**BEFORE THE PUBLIC UTILITY COMMISSION
OF OREGON**

LC 79

NORTHWEST NATURAL GAS
COMPANY, dba NW NATURAL,

2022 Integrated Resource Plan.

Figure 1: Actual and Modeled Forest Grove Average Daily Inlet Pressure vs Temperature⁴⁰

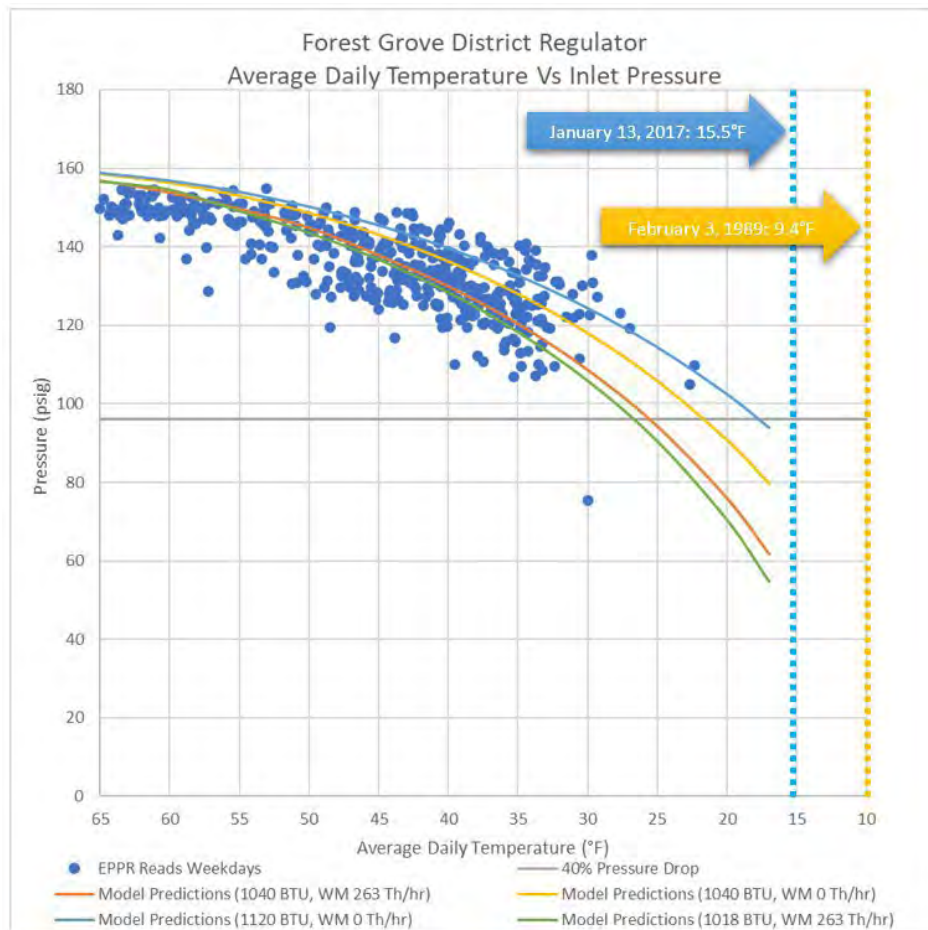
As shown in Figure 1, comparison of actual pressure data recordings at the District Regulator with the model results confirms a close match with random scatter points around four forecasted temperature-pressure curves representing different scenarios of BTU value and largest customer load.

Figure 1 shows that if historical temperatures of 15.5°F and 9.4°F (occurring in 2017 and 1989, respectively) were to recur at present, significantly large pressure drops of the inlet pressure would be expected in accordance with any of the load combination scenarios.

Figure 8.2: Distribution System Planning Process – Peak Hour

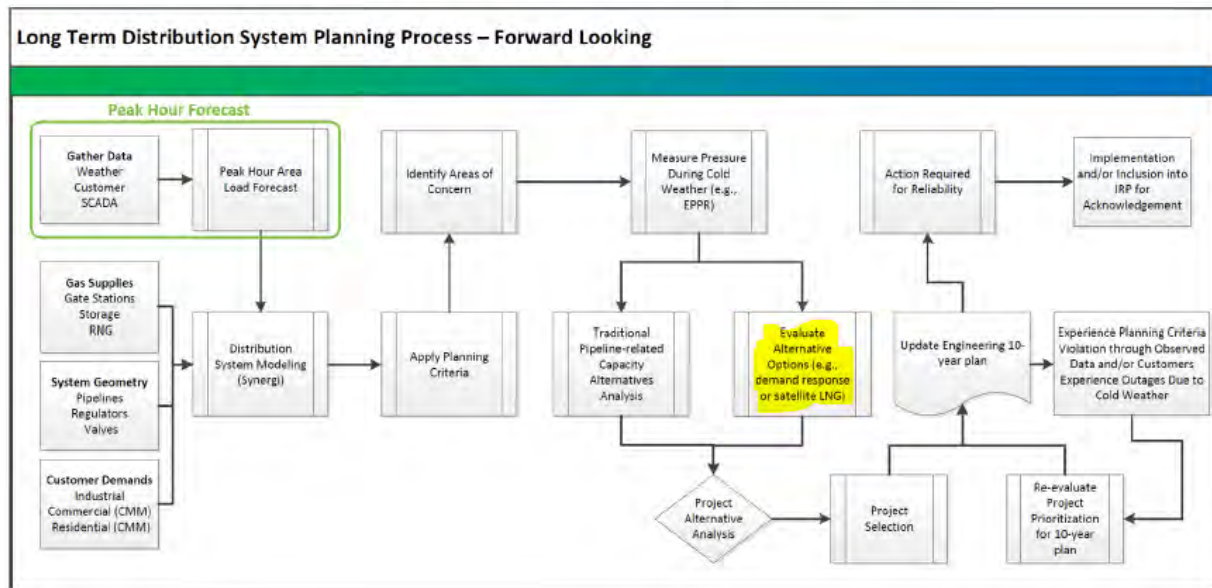
As demand side solutions require longer time to evaluate and analyze, presenting a project 2-3 years in advance does not give enough time for those alternative non-pipeline options to be considered on an equal footing.

Figure 3, Existing Demand Response Impact ⁶⁴

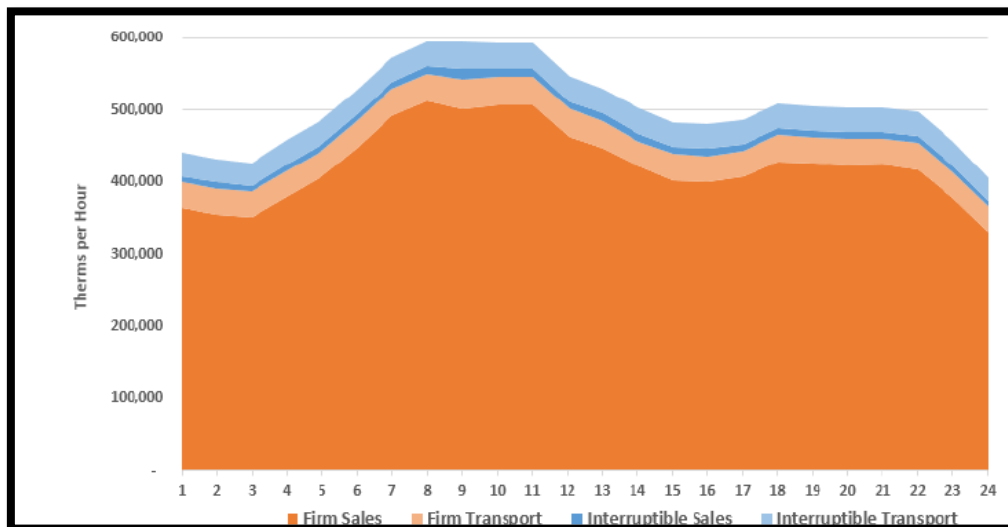
The figure above shows that approximately 2 percent of peak day sales load can be interrupted, and approximately 9 percent of total deliveries can be interrupted at peak.⁶⁵ To this end, Staff noted in its Opening Comments the extent to which future demand response capabilities naturally align with both interruptible and transport customers to control peak demand.⁶⁶

Figure 6: D3 RIN Prices 2021-Feb 10, 2023

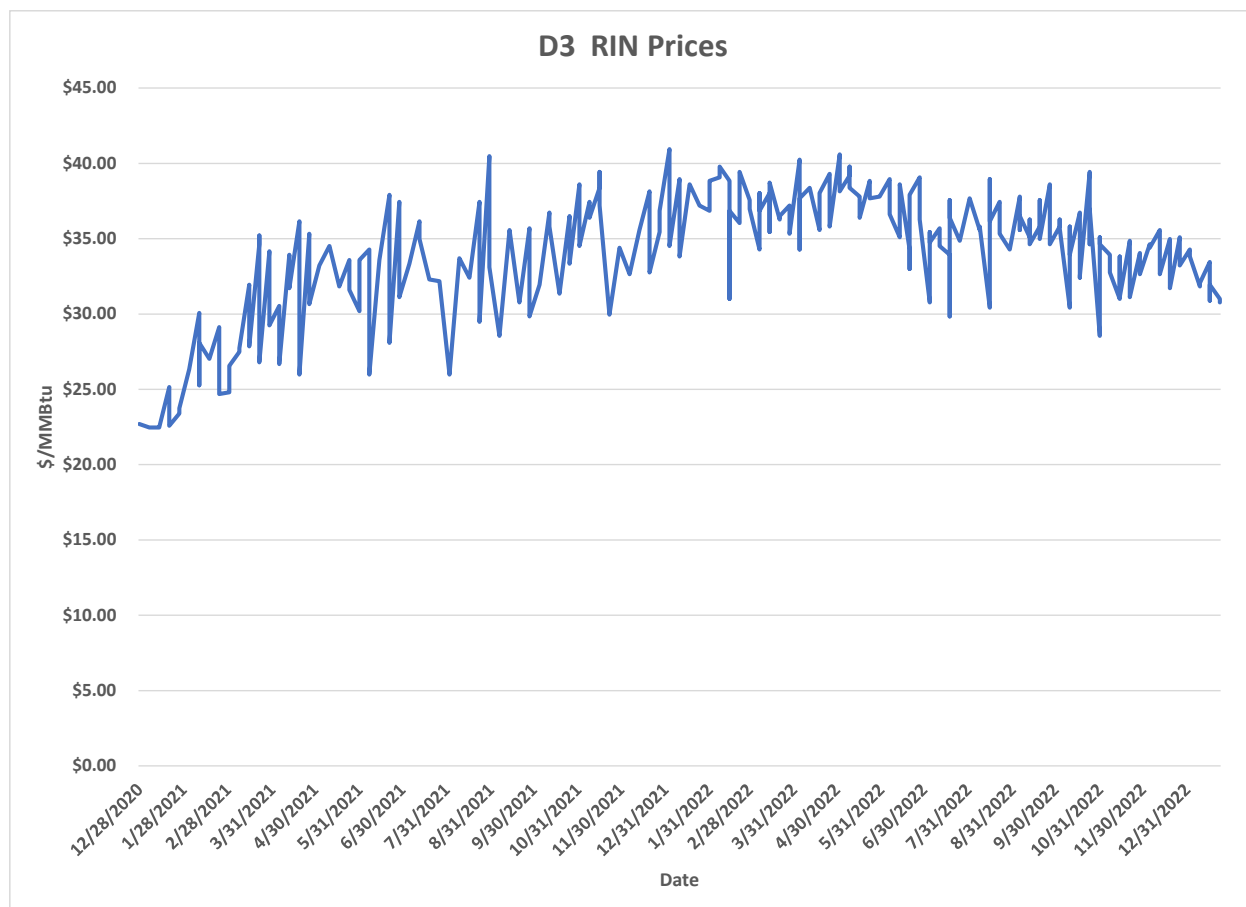
Staff continues to have concerns with the price forecasts for RNG used by the Company. Competition for RNG is high in the renewable fuel market. Transportation RNG, with its environmental attributes represented by D3 Renewable Identification Numbers (RINs), receives premium rates. Figure 6 below highlights the historic prices for D3 RINs as reported by the EPA for 2021 through February 10, 2023. The D3 RIN prices¹¹² have been higher than NW Natural's current RNG projections for Tranche 2, which is estimated at \$19/MMBtu. This means that NW Natural could have difficulty finding large quantities of RNG at prices much below prices of RIN RNG. In a recent filing, NW Natural discusses how the RNG market is driven by the fuels markets, including D3 RINs.¹¹³ The Company points out that while volatile, "the overall value or RNG in these markets remain strong, with a 2-year average of over \$33/mmbtu."¹¹⁴

Figure 13. NPV RR effect by scenario of substituting CCI credits for RNG, up to Allowed level of CCI credits

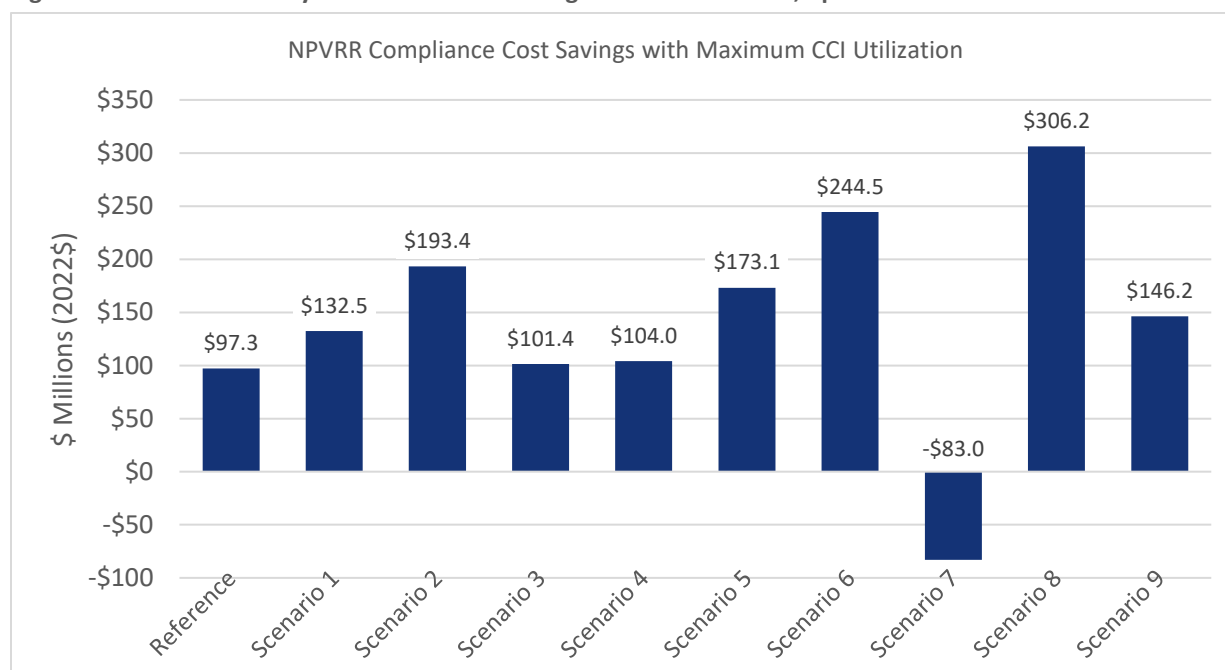
As seen in Table 4 and Table 5 above, the value of using CCI credits instead of procuring RNG to meet CPP compliance is at its highest when RNG costs are high, in Scenario 8. But in all scenarios except the low-cost RNG Scenario 7, using CCI credits at their maximum levels results in ratepayer savings.

Figure 17. Oregon CPP compliance costs by year by scenario (NWN)

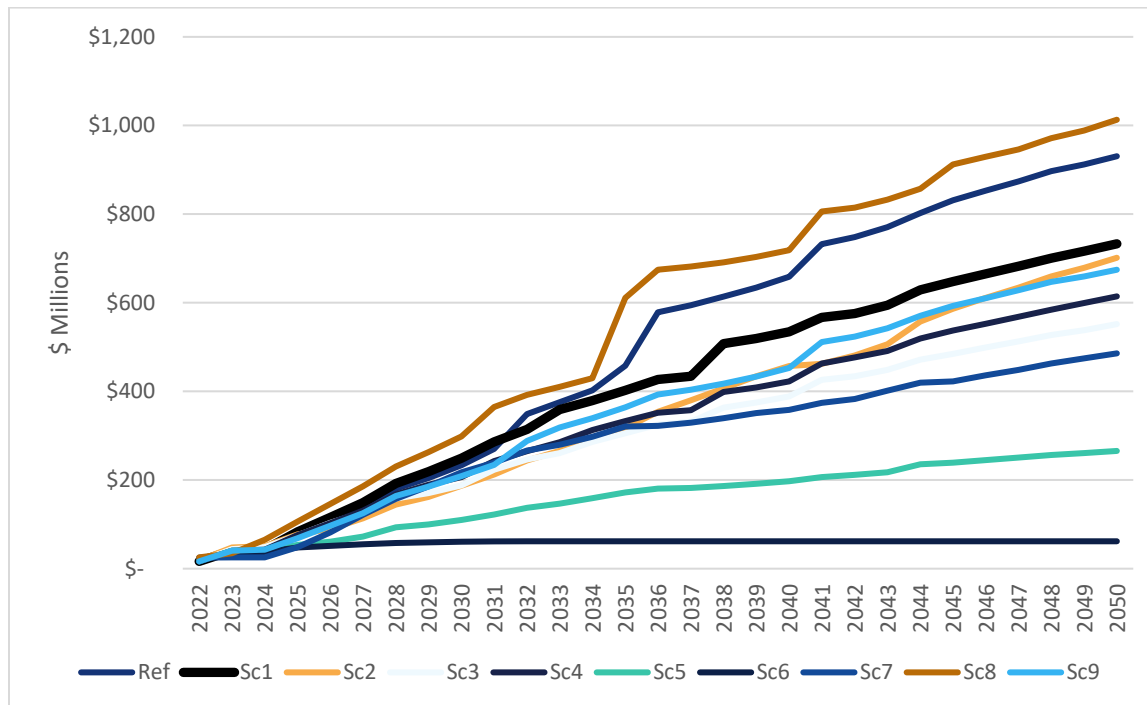
The lowest compliance costs are seen in Scenario 6, which contains the lowest level of gas load. The highest level of compliance cost is seen in Scenario 8, which is the only scenario that reflects a higher cost for RNG (biofuel, hydrogen, and synthetic methane fuels). The compliance cost streams are composed of RNG, CCI, and incremental demand-side management costs that in combination meet the CPP requirements for total emissions from the sales and transport sectors.

Figure 18. Comparison of NPVRR across all scenarios, inclusive of electrification cost estimate, 2022-2050

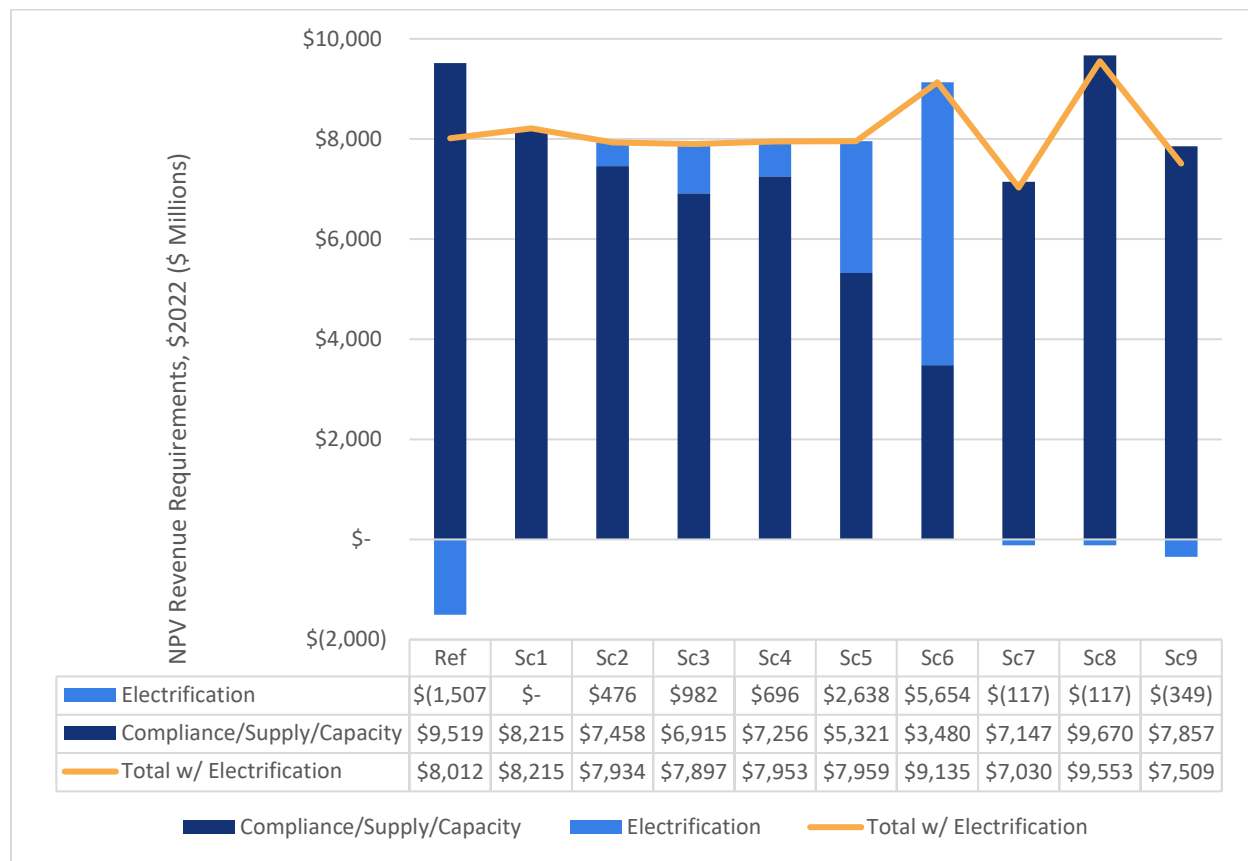
Figure 18 above illustrates the following:

The two figures shown above, Figure 18 and Figure 19, demonstrate how directly considering the costs of load not served by gas, but served by electricity, allows for a rough comparison across scenarios to gauge the relative value of planning solutions using RNG versus solutions with electrified load. These two paths result in the same, or at least analytically similar, levels of decarbonization. Uncertainty associated with the level of decarbonization resides in each pathway. For electrification pathways, there is uncertainty with the marginal greenhouse gas emissions associated with increased electrification-derived load. For RNG pathways, there is uncertainty associated with the true level of net emissions associated with the combustion of RNG. NWN does not directly address this risk in its analysis.

Figure 19. NPVRR comparison with electrification costs, CCI-for-RNG substitution, and distribution capex savings, 2022-2050

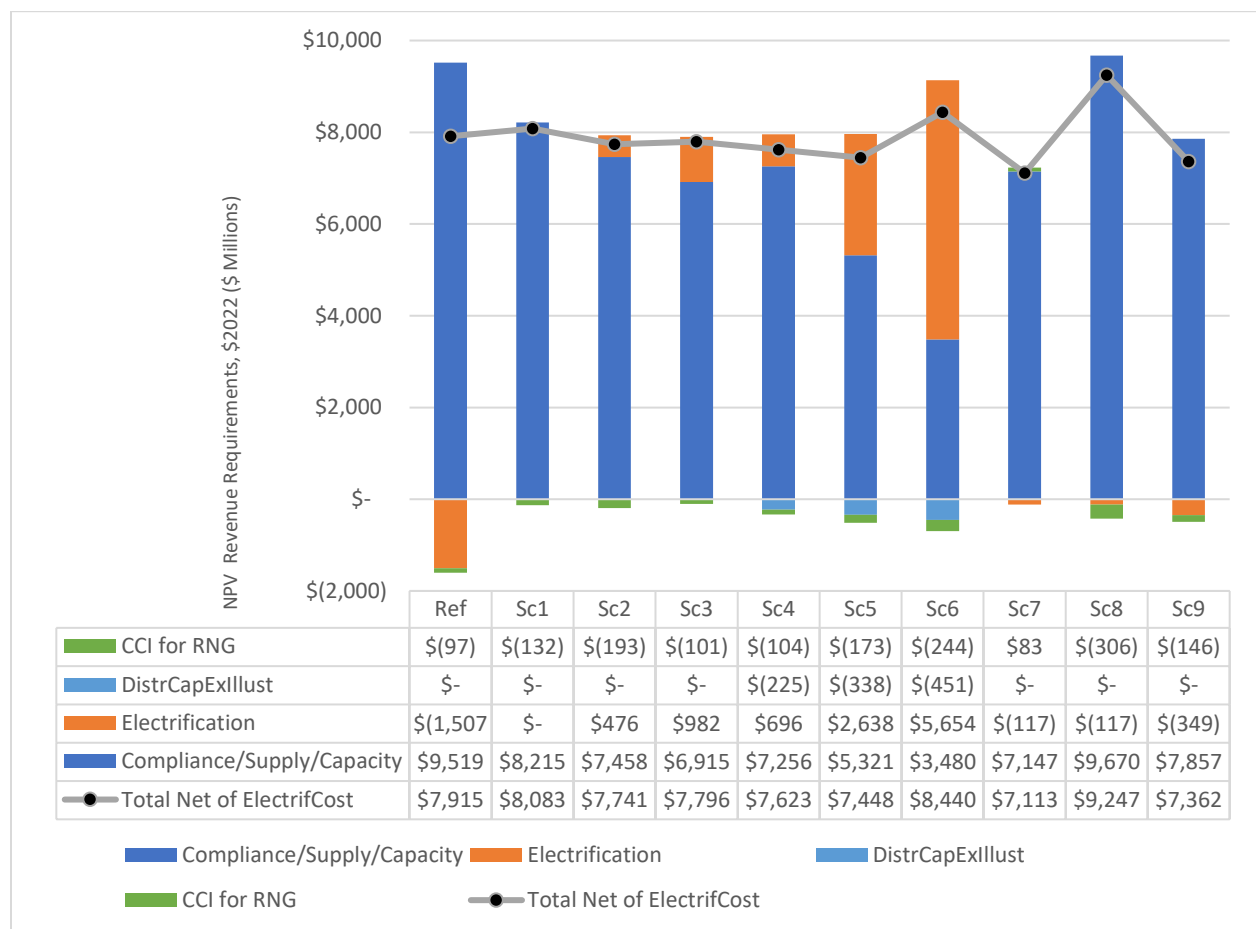
Figure 19 above illustrates that consideration of revenue requirement cost savings from alternative resource pathways can be used to compare outcomes against NWN’s preferred scenarios, in this case using Scenario 1 to reflect NWN’s preference.
